STAFF REPORT

Agenda Title: For Possible Action: To approve a Tentative Subdivision Map for a 204 lot single family residential subdivision in the Lompa Ranch North Specific Plan Area on property zoned Multi-Family Duplex and Single Family 6000, located south of East Robinson Street, west of Highway 395, and north of East Fifth Street, APN 001-041-71. (TSM-17-184) (Hope Sullivan, hsullivan@carson.org)

STAFF REPORT FOR THE PLANNING COMMISSION MEETING OF SEPTEMBER 26, 2018

FILE NO: TSM-17-184

Figure 5 – Preliminary Site Plan

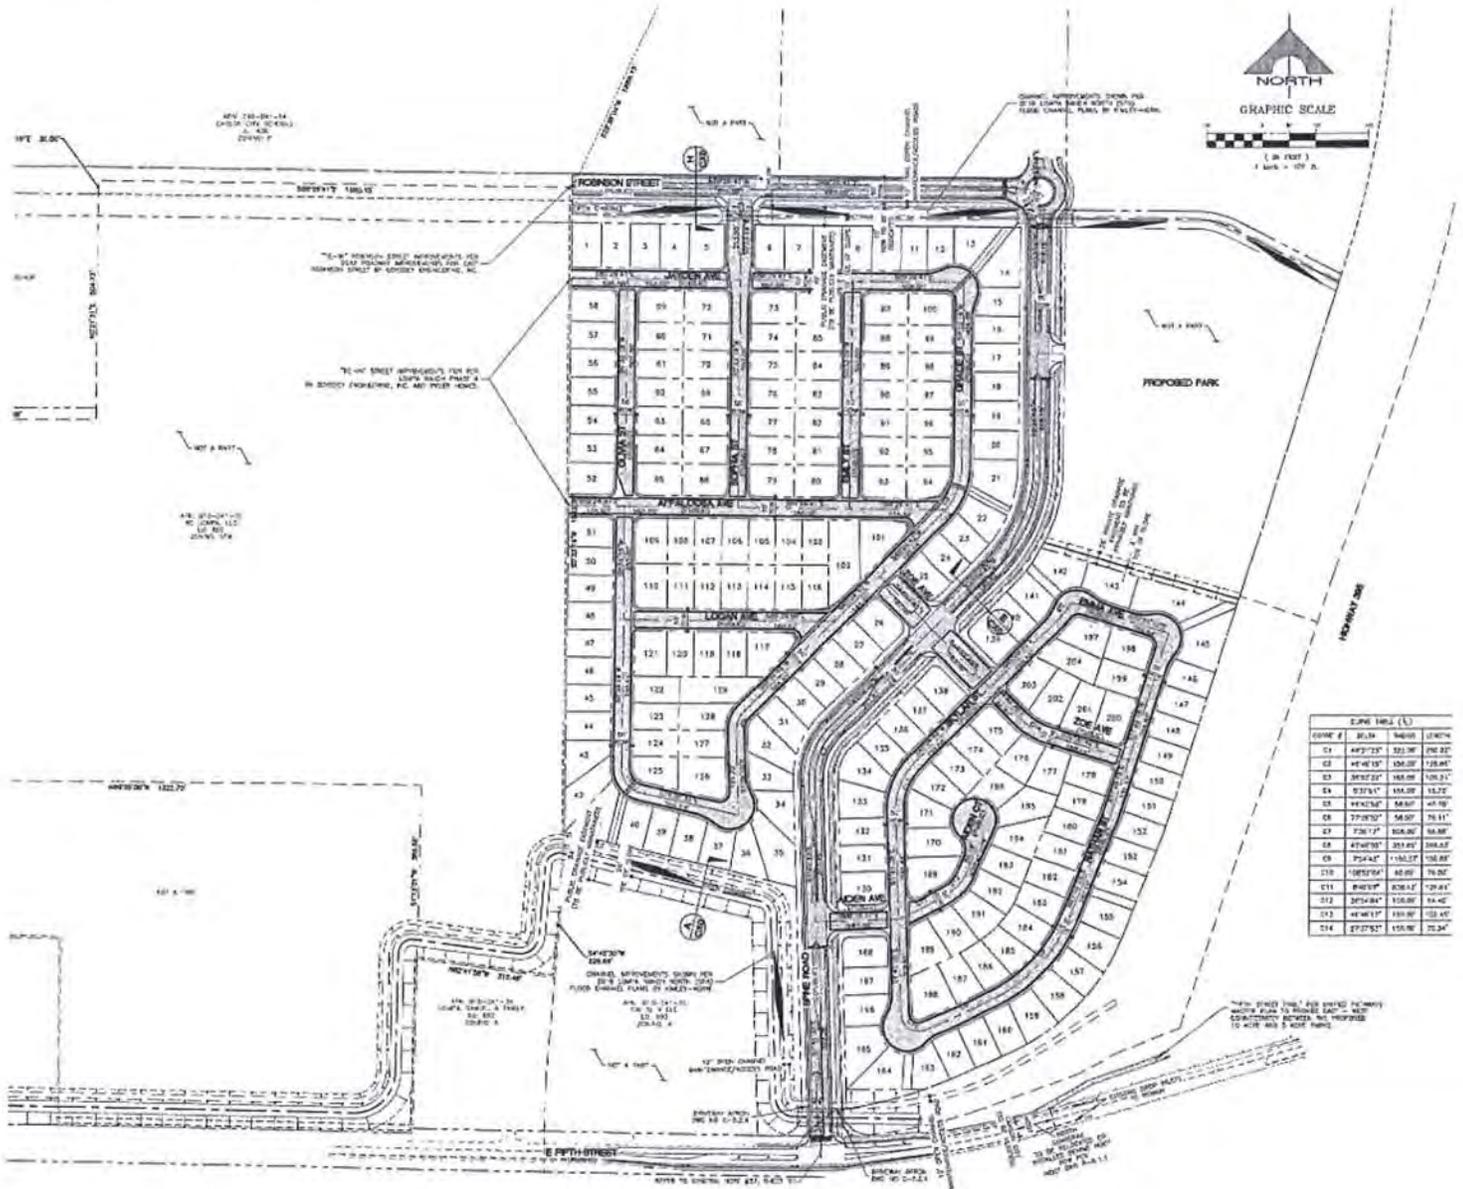
34. Sheet CS0: Demonstrate that the drainage channel located on the ten acre park area is at the northern edge of the park so as to not interfere with park programming, and will not exceed a width of 52 feet including the service road. No additional drainage facilities, including drainage easements, will be allowed on the park property and all drainage should be perpetuated within the channel or other facilities constructed outside of the park property.

5. Sheet CS0: Demonstrate that the area for the park will be ten acres and will not include a drainage facility. The drainage channel is not to be on park property.
